LINCOLN PARK PLANNING COMMISSION
CITY HALL – COUNCIL
CHAMBERS 1355 SOUTHFIELD
ROAD LINCOLN PARK, MICHIGAN

Quality Auto Wash
Site Plan Review

Applicant	Odell Lechevalier
Project	Quality Auto Wash
Address	4057 Dix Highway
Date	May 9, 2018
Request	Final Site Plan Review
Recommendation	Approve with Conditions

EXISTING SITE PLAN @ SCALE 1" = 20' - 0"

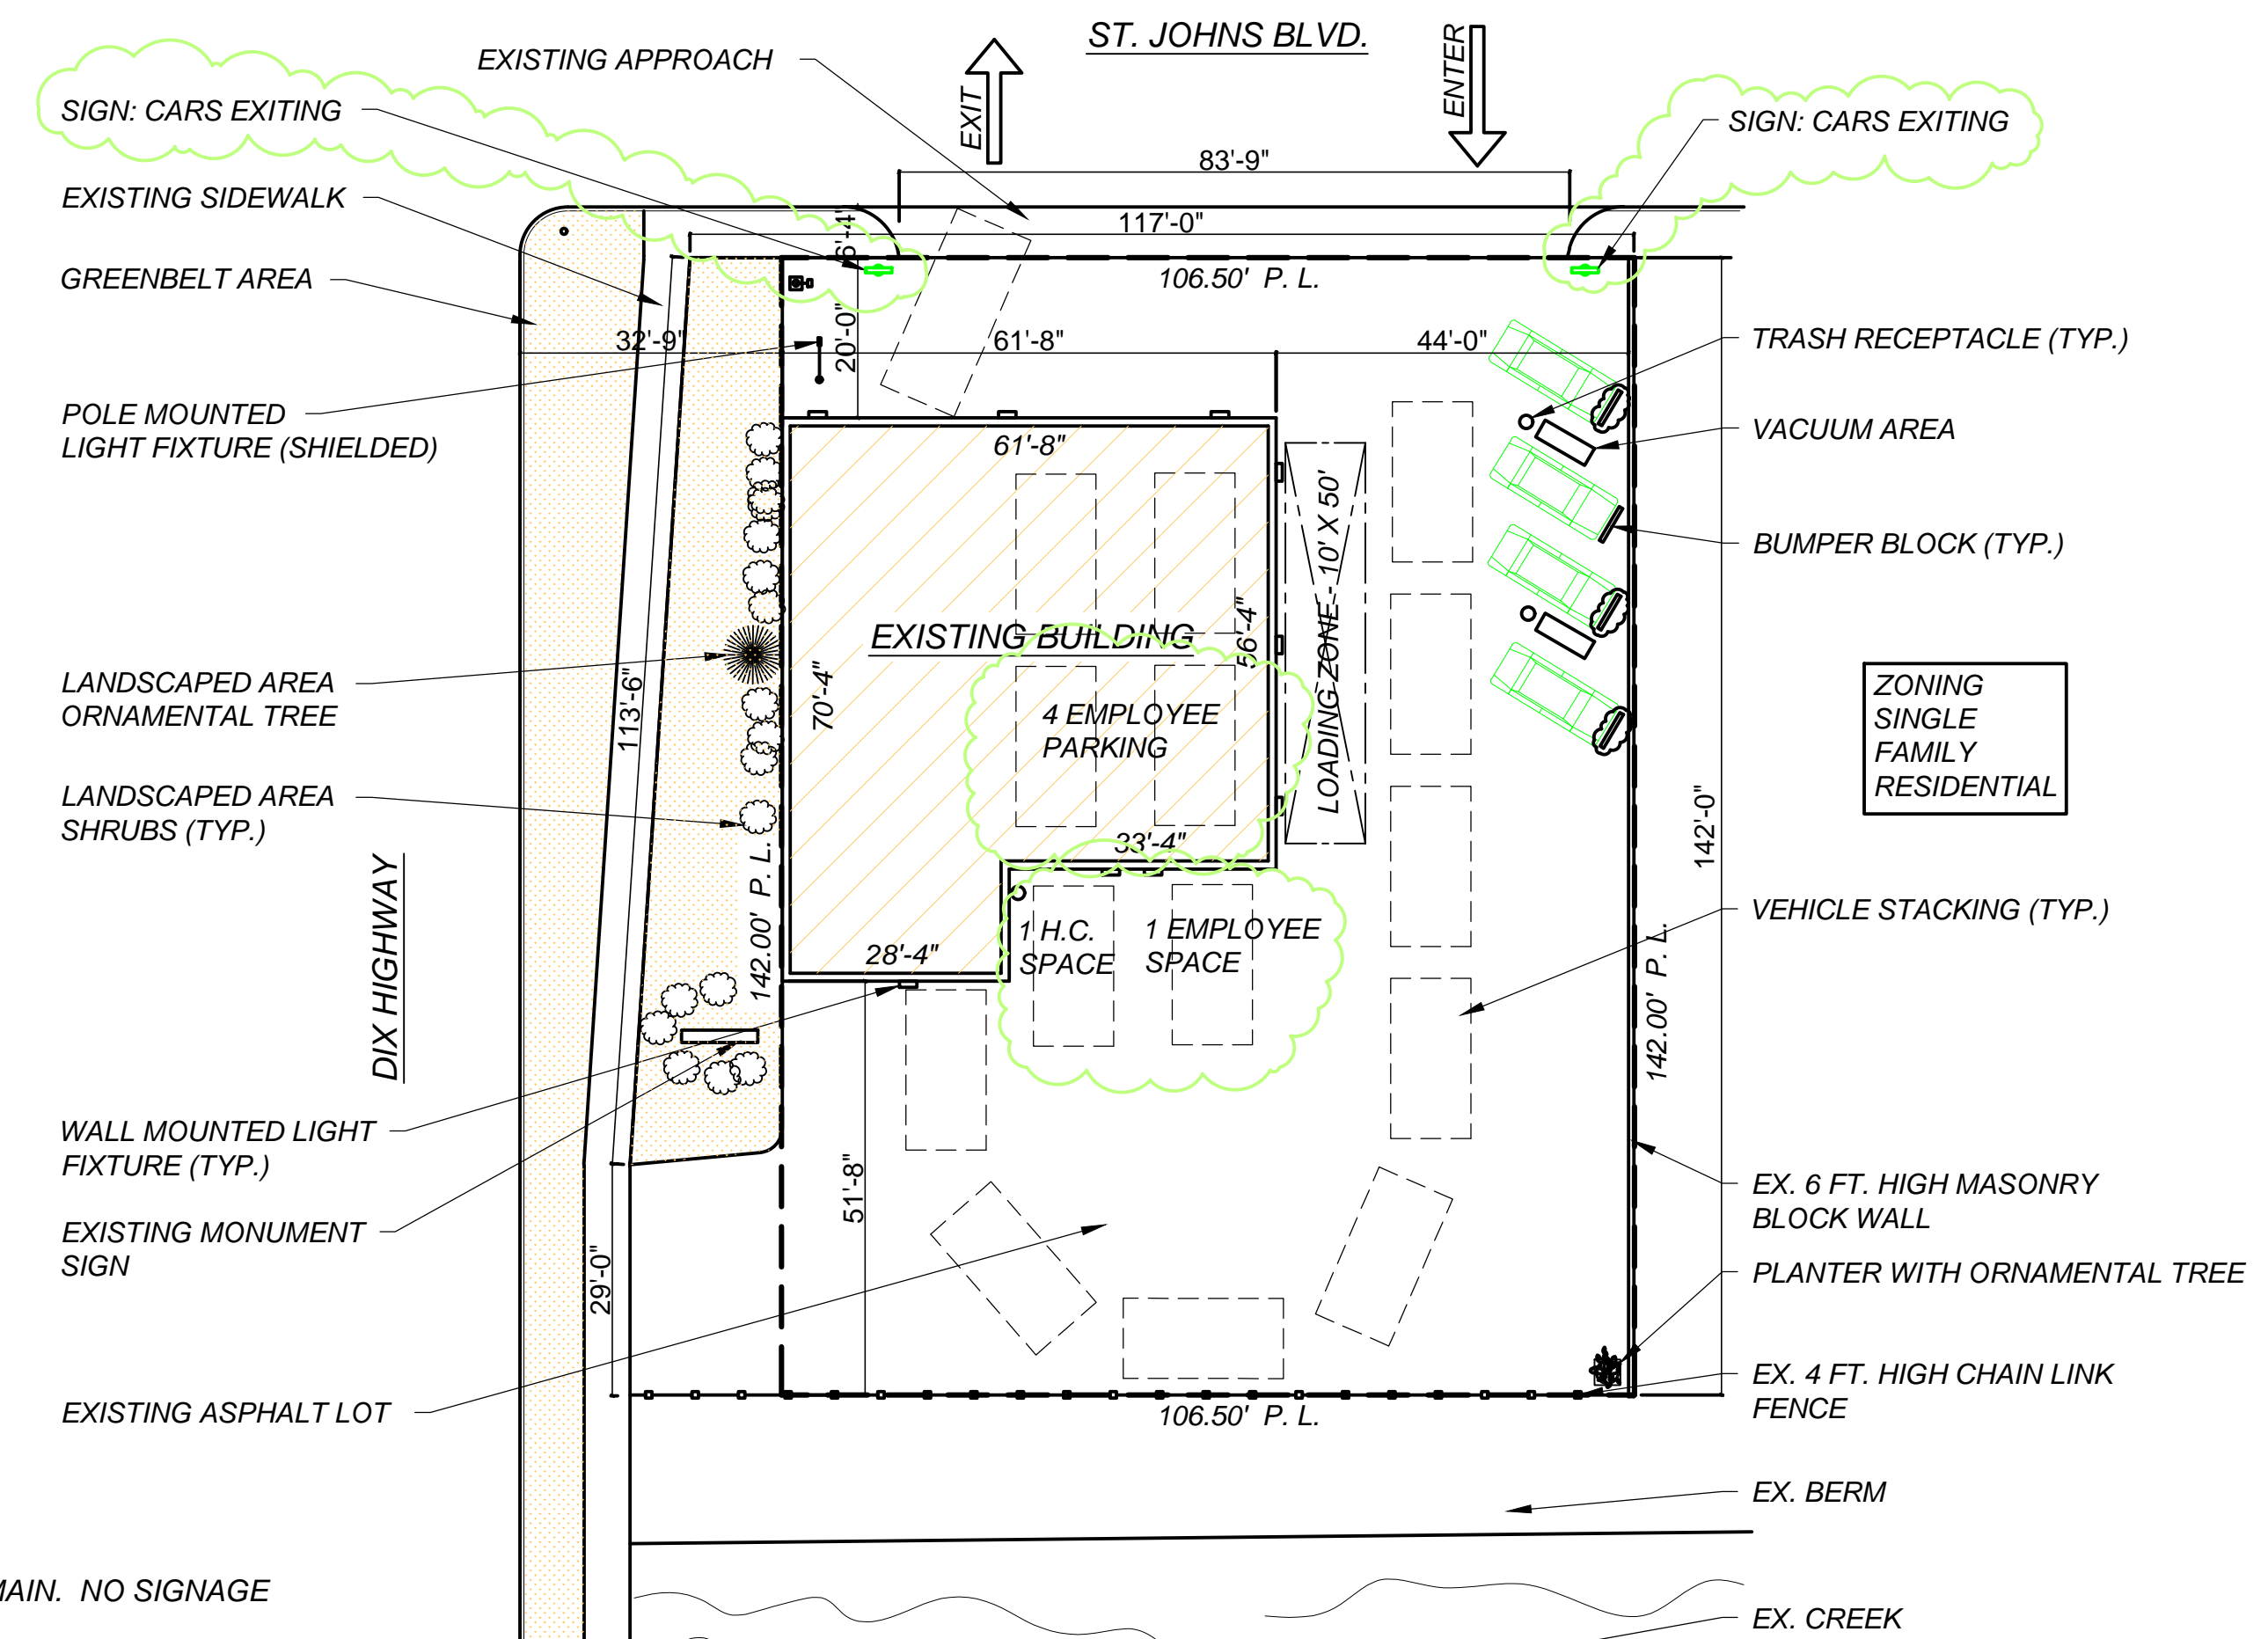
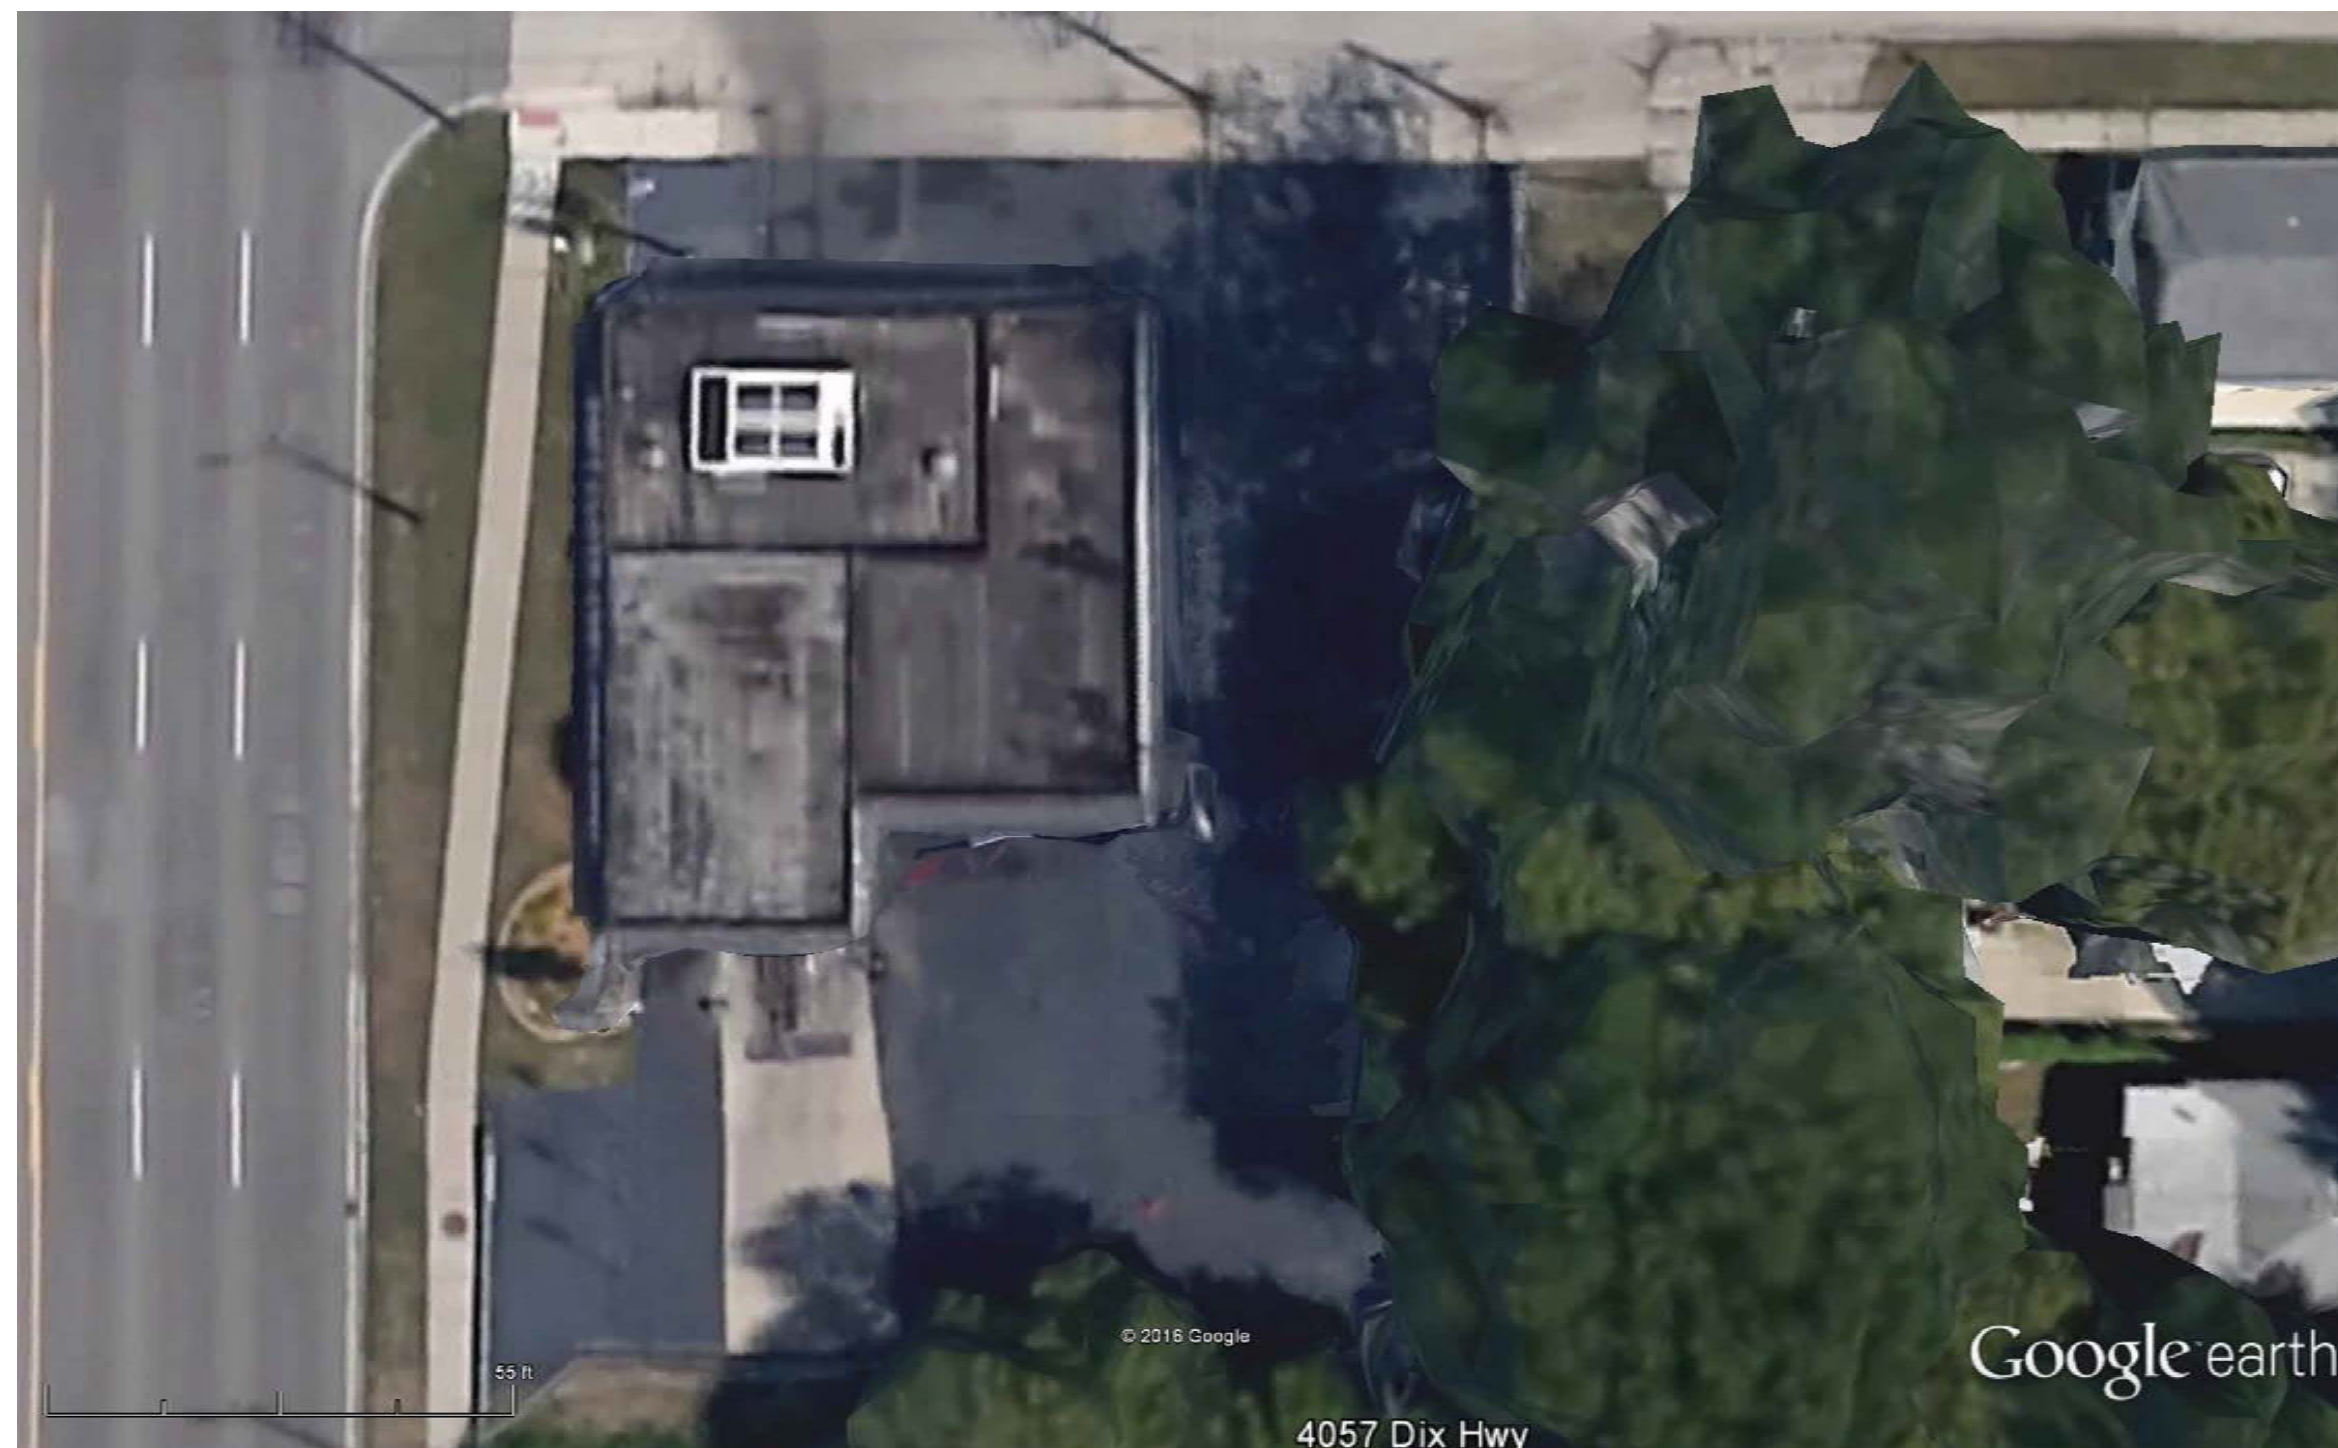
- *The site plan on SP-1 dated 3/29/2018 is labeled as 1" = 20' in scale and the elevation scale is noted as ¼"=1'on sheet A2. However, the measurements noted on the drawings do not correspond with measurements taken either with an engineering scale, or with a standard ruler and calculated. There is a puzzling note on the site plan that says, "Please do not scale drawings." A correctly scaled site plan must be provided, and a larger scale is recommended. The "provided" column are estimates by the City of Lincoln Park to conduct this review; all exceeded the requirement by a margin sufficient to determine compliance.*
- *Site plan shall show all proposed pavement markings.*

The vehicle stacking arrangement presented on Sheet SP-1 dated 3/29/2018 shows one line of 8 stacking spaces between the street and the entrance to the car wash. It is acknowledged that fitting the required 16 stacking spaces onto this site is a challenge that it may not be possible to meet. Once the most desirable arrangement has been developed by the applicant and approved by the Planning Commission, the City will support a variance request to waive any outstanding stacking spaces in consideration of the site’s constraints and the intervening regulatory requirements.

- Applicant to show curbs, gutters, and wheelstops where required
- Parking lot to be brought up to City standards
- Applicant to show parking space dimensions, ensuring that they correspond with the parking pattern in which they are arranged
- Applicant to seek variance to exceed parking requirements by more than 20%
- Applicant to seek variance to provide 8 stacking spaces rather than 16

- *As with the rest of the drawing, the loading dock is not correctly scaled. Applicant to ensure that revised drawings correctly show the required 10'x50' loading space.*

- The site plan on SP-1 dated 3/29/2018 is labeled as 1" = 20' in scale and the elevation scale is noted as 1/4"=1' on sheet A2. However, the measurements noted on the drawings do not correspond with measurements taken either with an engineering scale, or with a standard ruler and calculated. There is a puzzling note on the site plan that says, "Please do not scale drawings." A correctly scaled site plan must be provided, and a larger scale is recommended. The "provided" column are estimates by the City of Lincoln Park to conduct this review; all exceeded the requirement by a margin sufficient to determine compliance.*

- Applicant to seek variance to provide 8 stacking spaces rather than 16*
- Applicant to provide the dimensions of one barrier-free parking space, which must be at least 12' in width.*

- As with the rest of the drawing, the loading dock is not correctly scaled. Applicant to ensure that revised drawings correctly show the required 10'x50' loading space.*
